## D/DRC Case

1703 Wayne Street

**DESIGN/DEVELOPMENT REVIEW COMMISSION**  
**DESIGN REVIEW DISTRICT**  
**CONSENT AGENDA**  
**EVALUATION SHEET**  
**Case # 4**

**NATURE OF REQUEST:** Request for preliminary approval for the Bailey Bill

6.1 Item 1(Picture) PLYWOOD STAINED

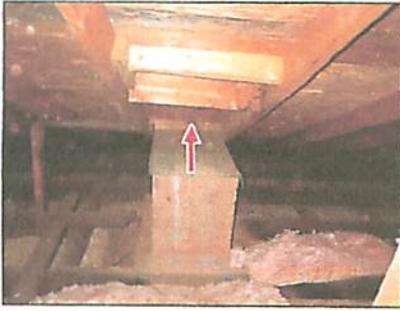
**6.1 ATTIC - PLYWOOD STAINED:** Found water stains/discoloration in the plywood sheathing at in the valleys at the left side and various locations.

*Note: Plywood was dry at the time of inspection during dry weather. Note: No significant damage found.*

6.3 Item 1(Picture)

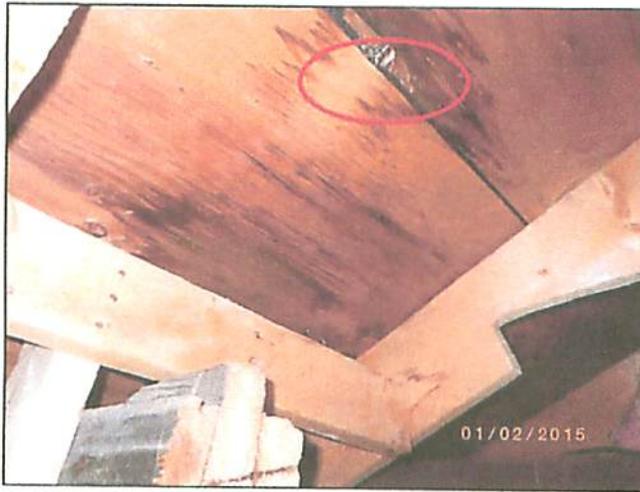
6.3 ATTIC - LEFT SIDE: Roof framing has been added where the brick chimney has been removed.

Note: See Item 1.1 (sag in roof).

6.4 Item 2(Picture) HOLE IN ROOF

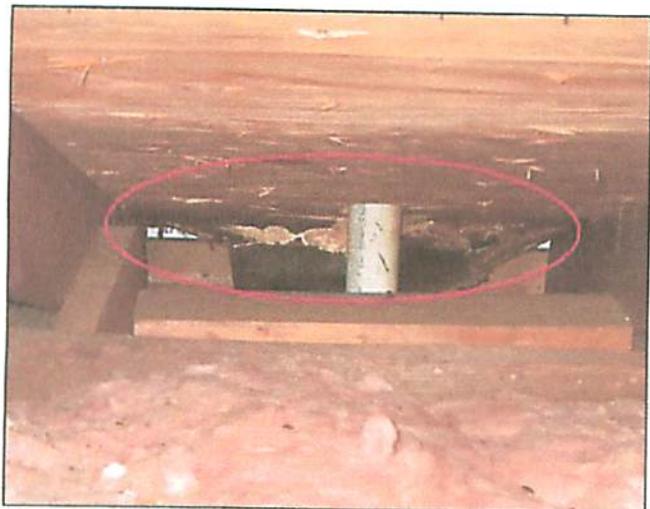
6.4 HOLE IN ROOF - ABOVE ACCESS: Found visible light through-the-roof sheathing (stained) above the drop-down ladder.

Note: See Item 1.0 (hole in shingles).

15.0 Item 1(Picture)

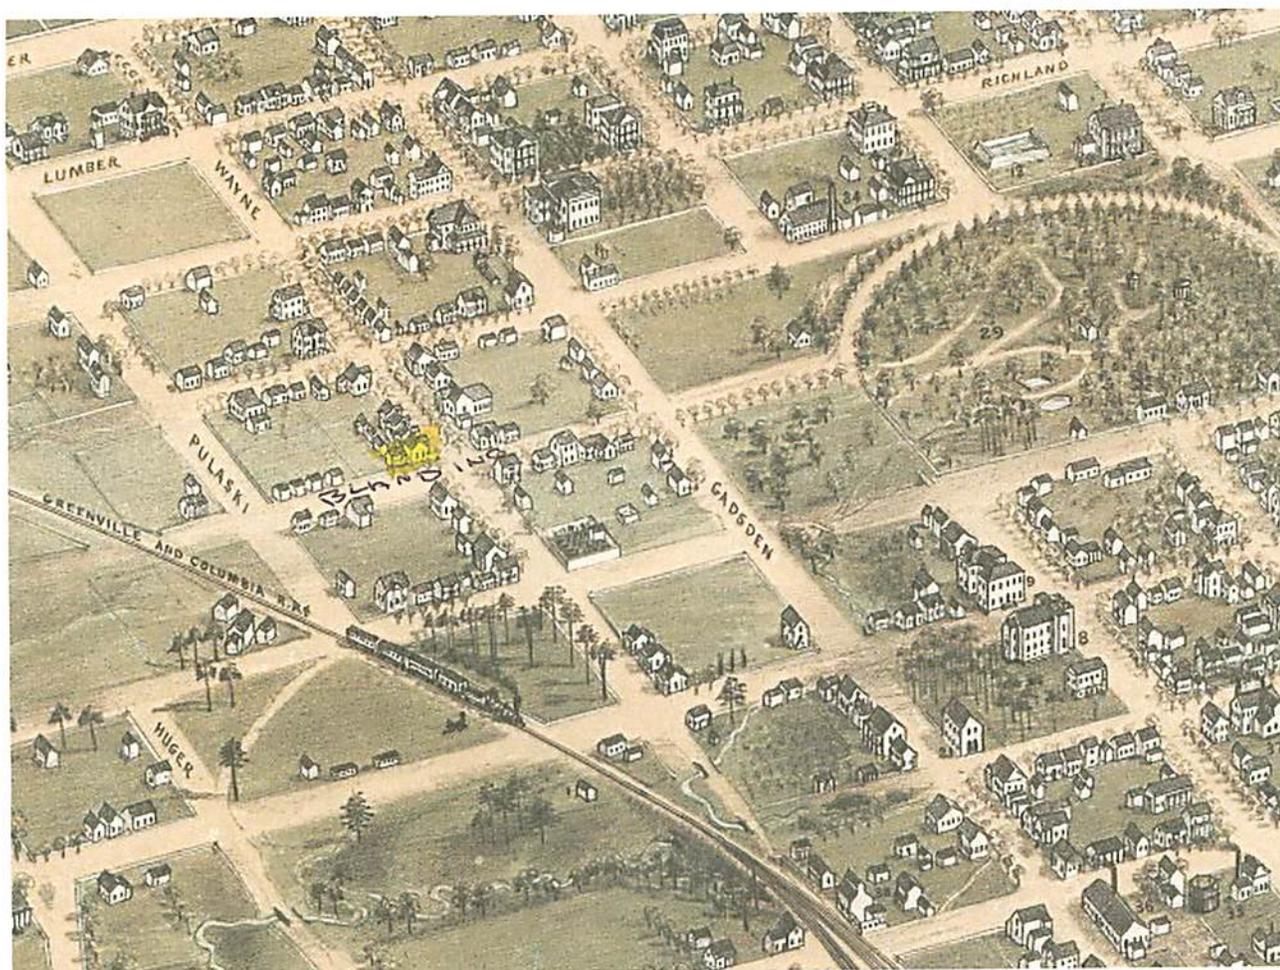
15.0 FIREPLACES: The fireplaces in the building have shallow firebox. These type of fireplaces generally were intended for burning coal. Typically there are no flue liners as installed in wood burning fireplaces.

*Note: Fireplaces have been blocked off or partially sealed. Do not attempt to use with combustible materials.*

**Recommend a qualified chimney sweep or fireplace specialist inspect all fireplaces further before use for safety concerns.**
